UNITED STATES PATENT AND TRADEMARK OFFICE

APPLICATION NO.	FILING DATE	FIRST NAMED INVENTOR	ATTORNEY DOCKET NO.	CONFIRMATION NO.
10/698,192	10/31/2003	James K. Middlebrook	31254-2	9975

Office Action Summary	Application No. 10/698,192	Applicant(s) MIDDLEBROOK ET AL.	
	Examiner Thai-Ba Trieu	Art Unit 3748

DETAILED ACTION

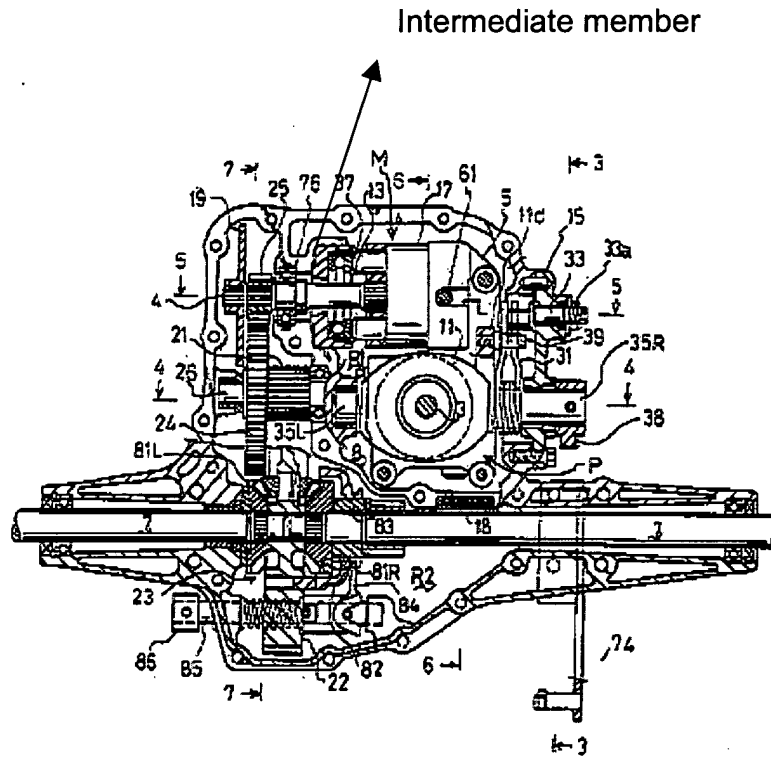
Regarding claims 8 and 15, Ishii discloses:

a rotatable shaft (4,7) (See Figures 2-3);

at least one bearing assembly (37) disposed around a portion of the rotatable shaft (4, 7) (See Figures 2-3);

a housing element (1,2) surrounding the bearing assembly (76, 37, and bearings support shaft 7); and

an intermediate member (Not Numbered) disposed between the bearing assembly (37) and the housing element (1, 2) (See Figure 2).

wherein the intermediate member (Not Numbered) is substantially cylindrical (See Figure 2).

Figure 1

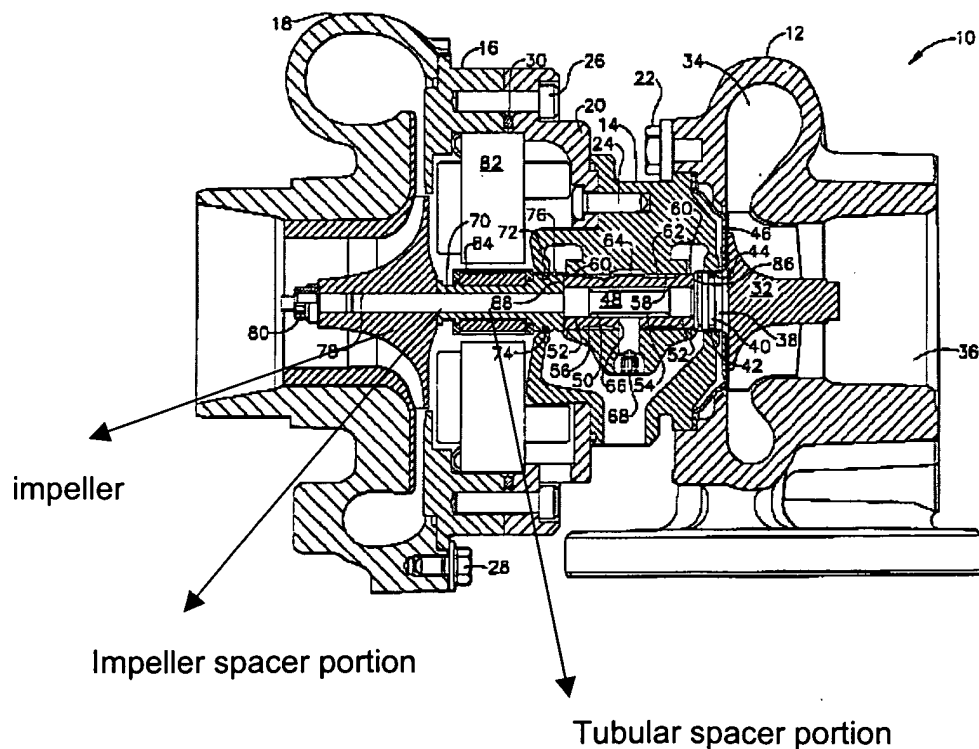
Allen discloses a supercharger, comprising:

an impeller shaft (48);

an impeller (Not Numbered) directly mounted on to the impeller shaft (48);

at least one bearing assembly (60) positioned around a portion of the
impeller shaft (48);

a spacer assembly (70) positioned between the impeller (Not Numbered) and the bearing assembly (60) (See Figure 1);

wherein the spacer assembly further comprises an impeller spacer positioned adjacent to a base of the impeller (See Figure 1);

wherein the spacer assembly (18) comprises a tubular spacer positioned around a portion of the impeller shaft (See Figure 1);

wherein the spacer assembly (70) is structured to couple the impeller (Not Numbered) to the bearing assembly (60) (See Figure 1).
